PLAN AND ZONING COMMISSION MEETING

TUESDAY, FEBRUARY 20, 2018; 5:00 PM

City of Davenport
Community Planning & Economic Development Department
PUBLIC HEARING REPORT

Meeting Date: February 20, 2018
Request: C-2 General Commercial to R-6M Planned Unit Development
Address: Lot 3 Ryde High 2nd Add'n – S of E 46th St between Grand & Tremont Aves
Case No.: REZ18-01
Applicant: David Meyer on behalf of Tom Swanwick dba Forest View LLC

Plat (with approximate zoning district line)

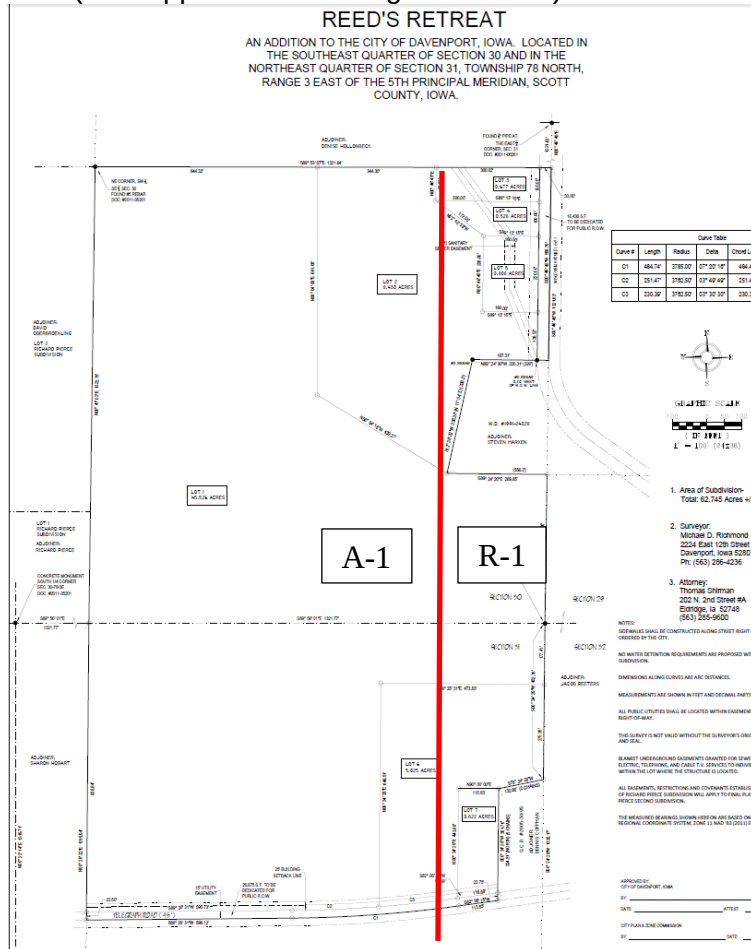
Streets. No new streets are proposed with this request. However the subdivision ordinance requires the developer to provide additional information such as noting the surface types of existing streets and showing the proposed right-of-way widths for Wisconsin Avenue and Telegraph Road as 45' from existing centerline.

Additional information is required by ordinance to be shown on the plat to aid in future development of the area. All existing buildings will need to be shown on the plat. This will verify future setback compliance from proposed property lines. Areas of significant tree massing should be outlined on the plat. Typically this highlights area of significant slope (untilled ground) or existing or potential conservation areas available to the developer. Existing contours will also need to be shown at five (5) foot intervals or less. This also highlights areas of significant slope where the developer should be cautious when planning future development. Finally a vicinity sketch will need to be added to this plat.

Re: Proposed Preliminary Plat of Reed's Retreat

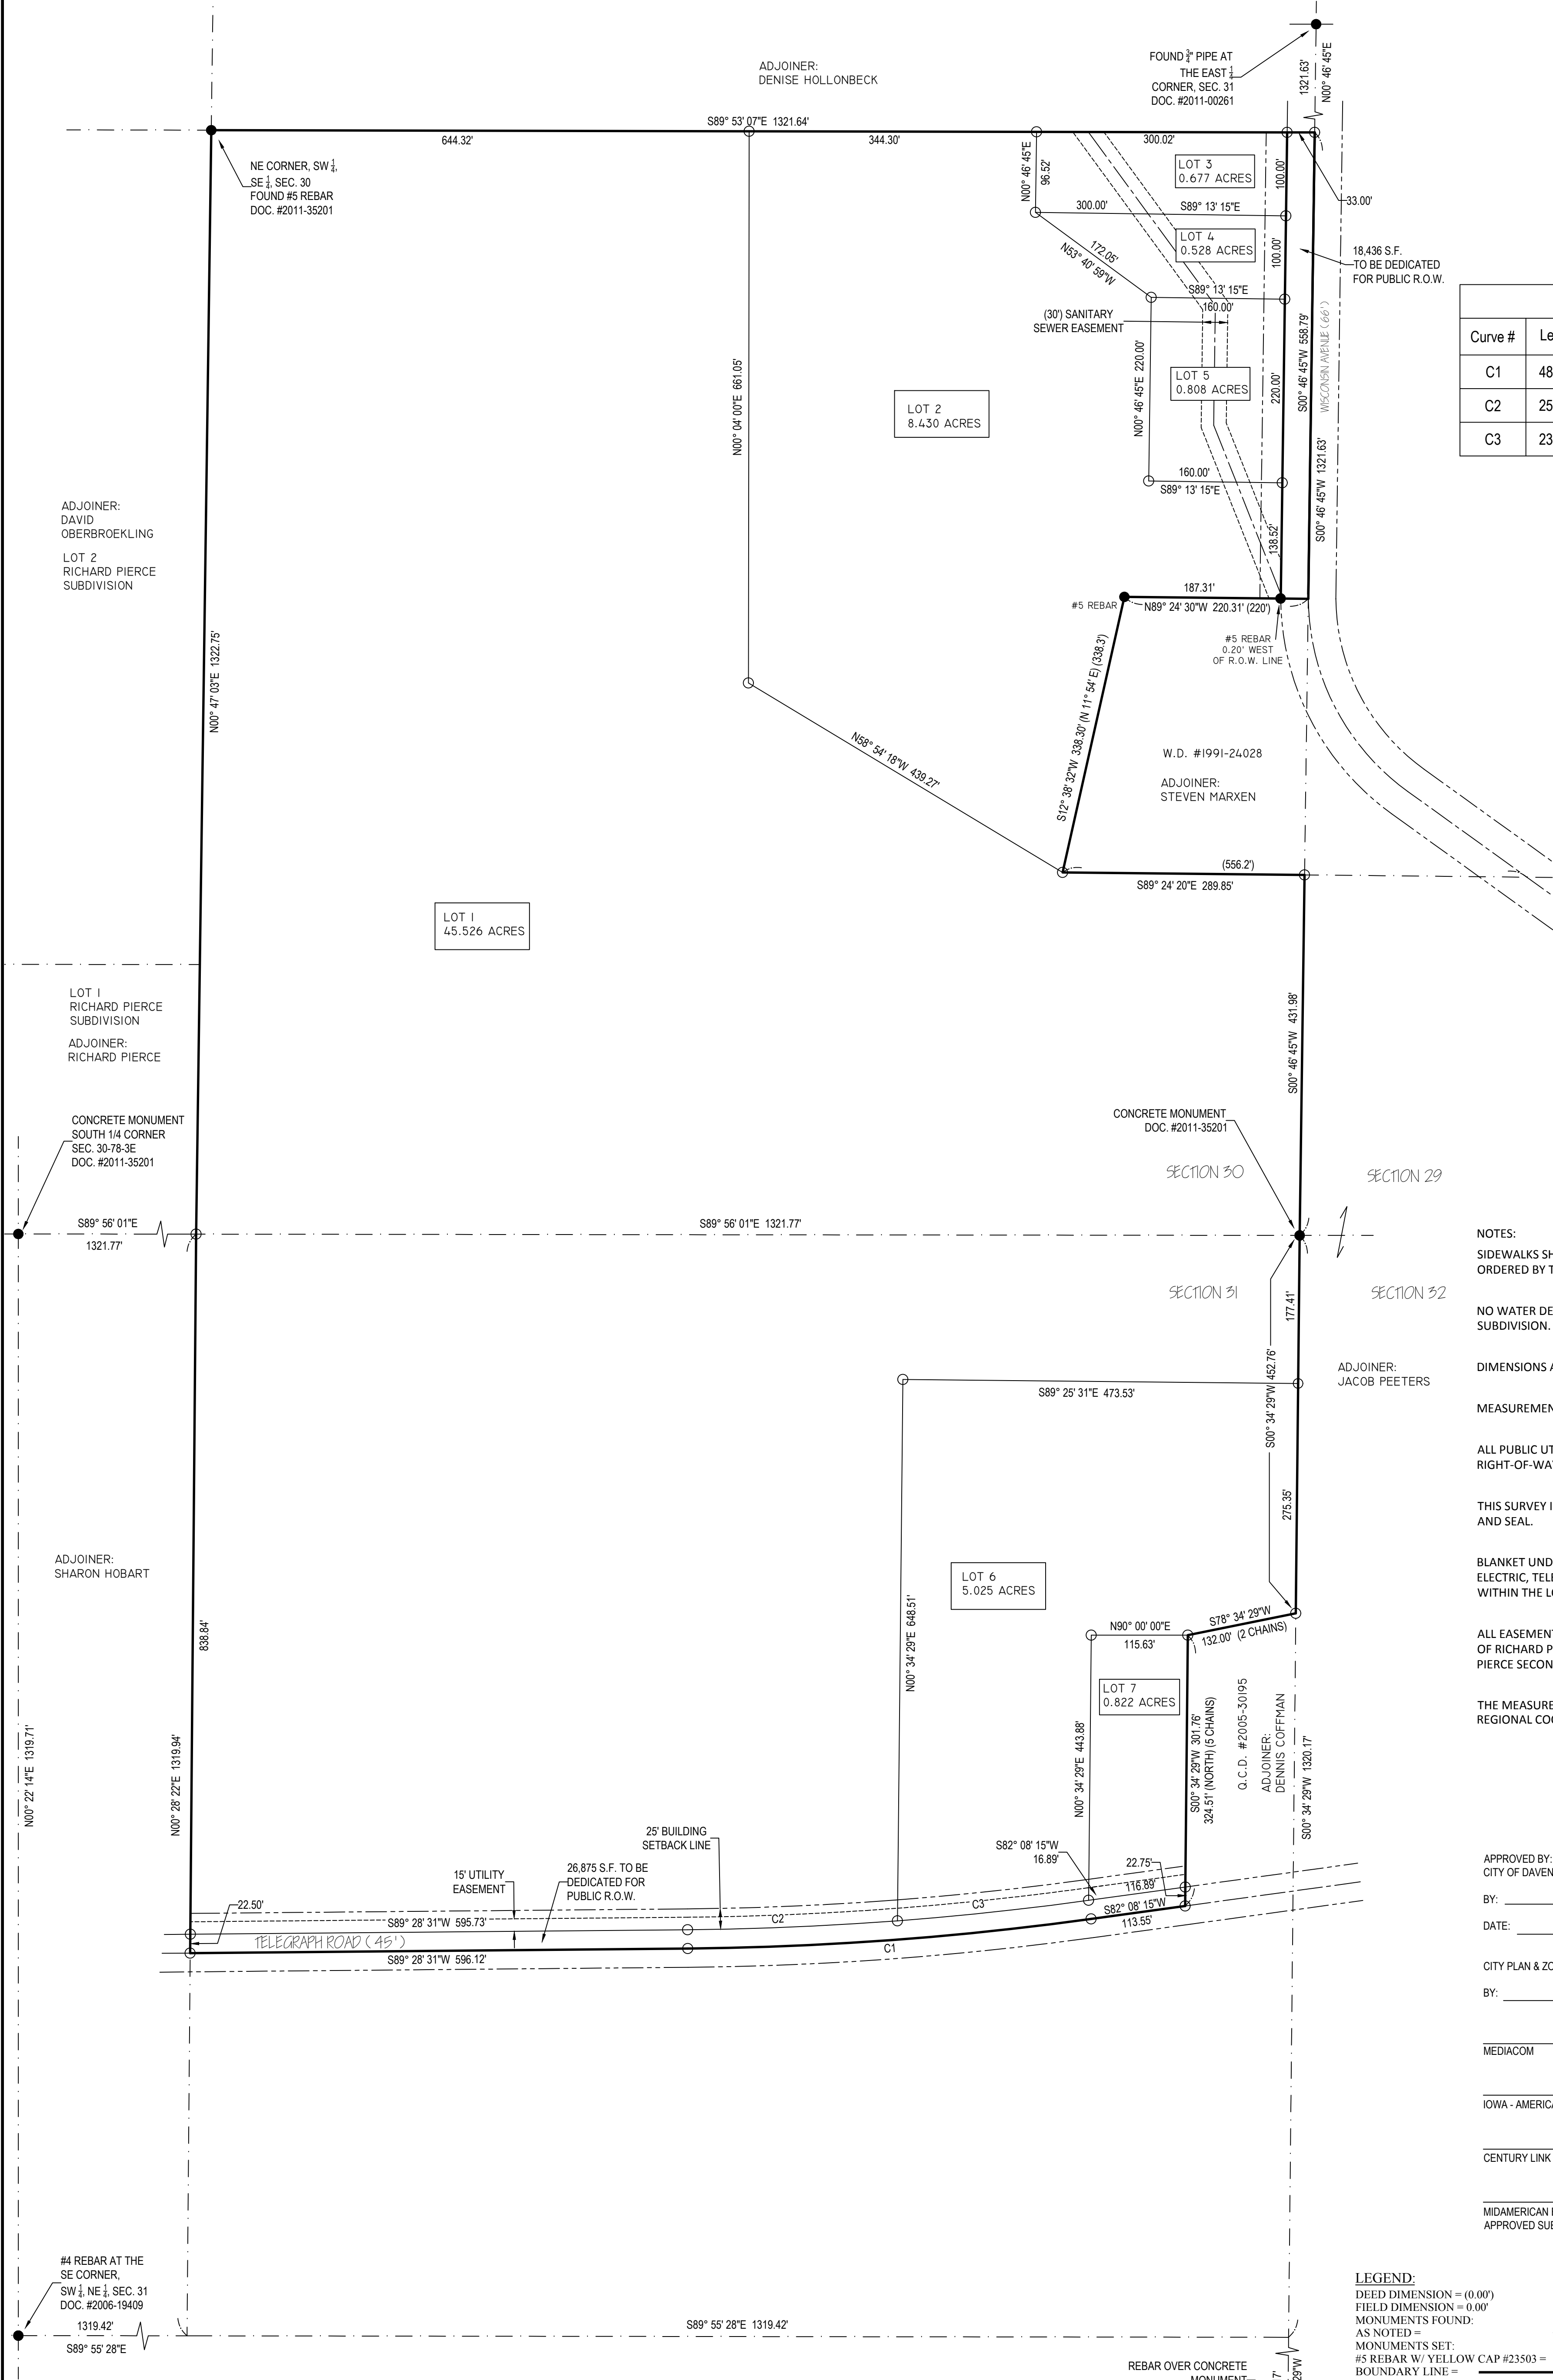
1. Existing buildings be shown.
2. Existing water courses are shown.
3. Existing tree masses are shown.
4. The size and location of existing sanitary sewers are shown.
5. The size and location of all existing culverts and storm sewers are shown.
6. The size and location of the existing water mains are shown.
7. All proposed and existing easements are shown.
8. All known underground structures are shown.
9. Existing contours are shown at intervals of 5' or less.
10. Names and boundaries of existing adjacent subdivisions are shown.
11. A vicinity sketch is shown.
12. Zoning is shown.
13. The surface types of existing streets are shown.
14. That the proposed ROW widths for Wisconsin Avenue and Telegraph Road are shown as 45' from existing centerline.

Re: Proposed Final Plat of Reed's Retreat

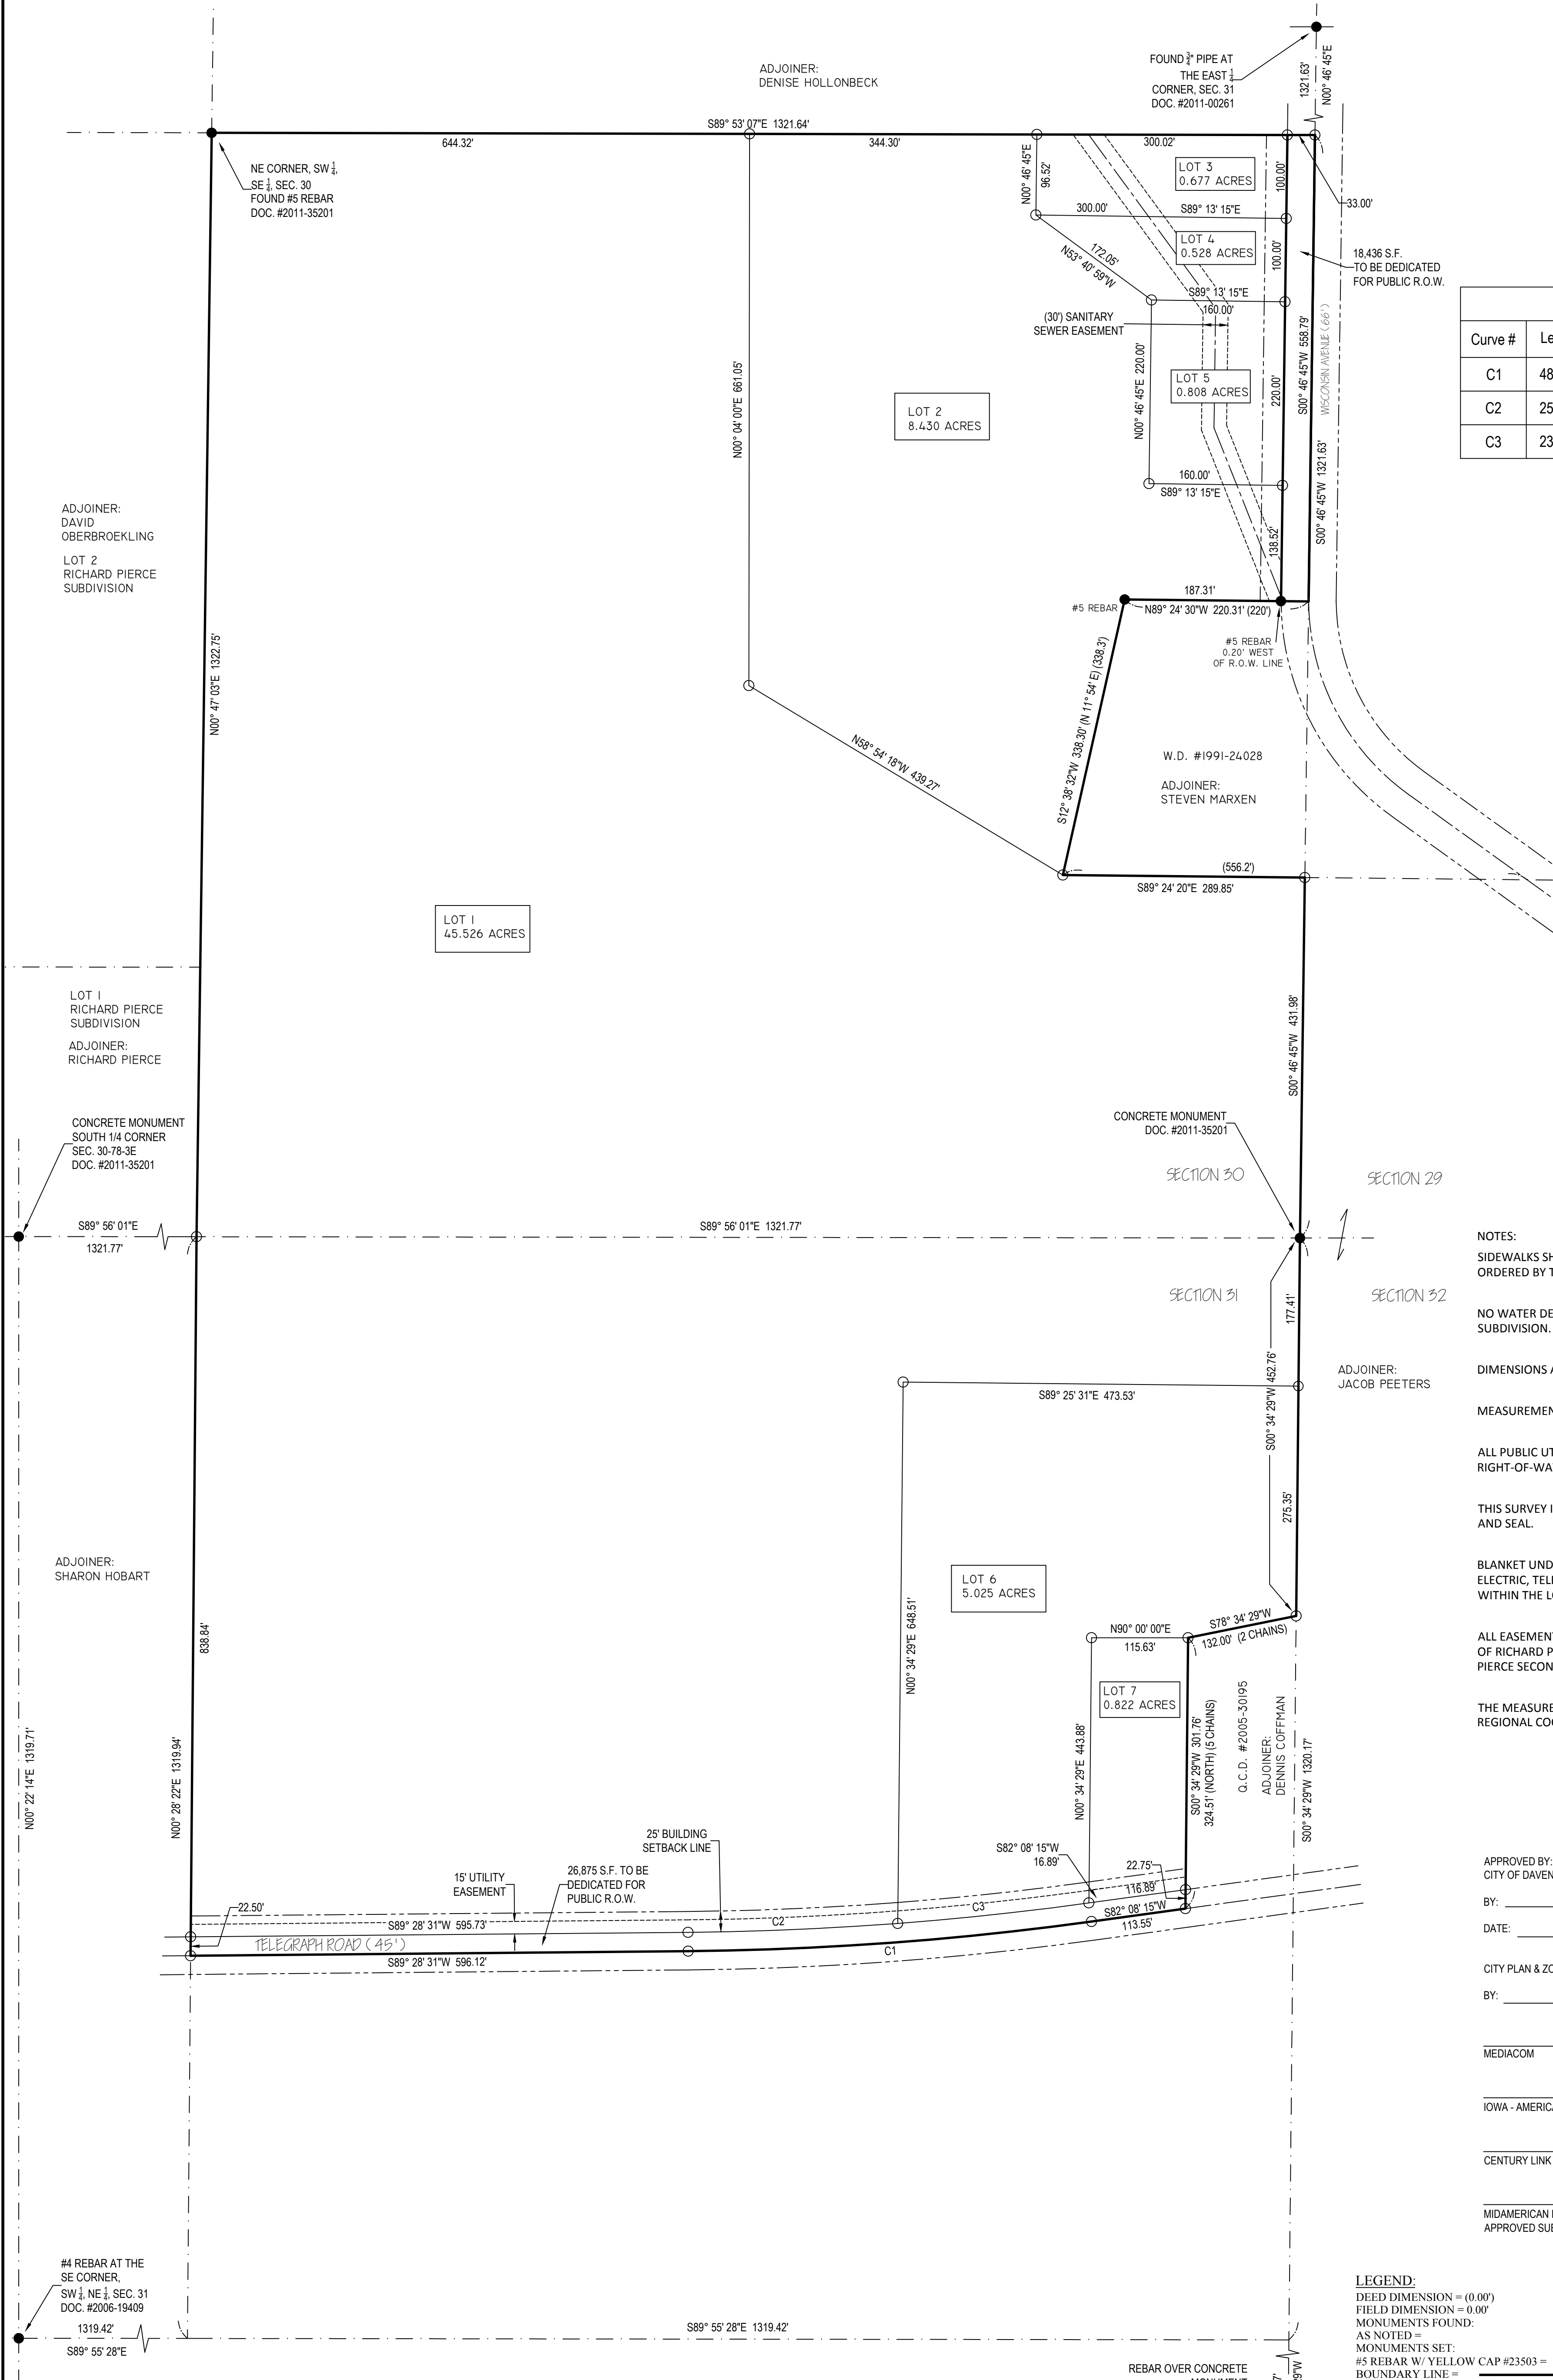
1. The surveyor signs the plat.
2. A 15 ft wide utility easement is dedicated along all street frontages including Wisconsin Avenue.
3. The utility companies sign the plat when their easement needs have been met.
4. The Owner/Developer's name and address are shown.
5. Dimensions are shown for the existing sanitary sewer easement and that the easement is tied to the plat in a manner that it can be located in reference to property corners.
6. An additional 12' of right-of-way is dedicated along Wisconsin Avenue bringing the total to 45' from existing right-of-way/easement centerline.
7. Additional right-of-way is dedicated along Telegraph Road as needed to bring the total width to 45' from existing right-of-way/easement centerline.
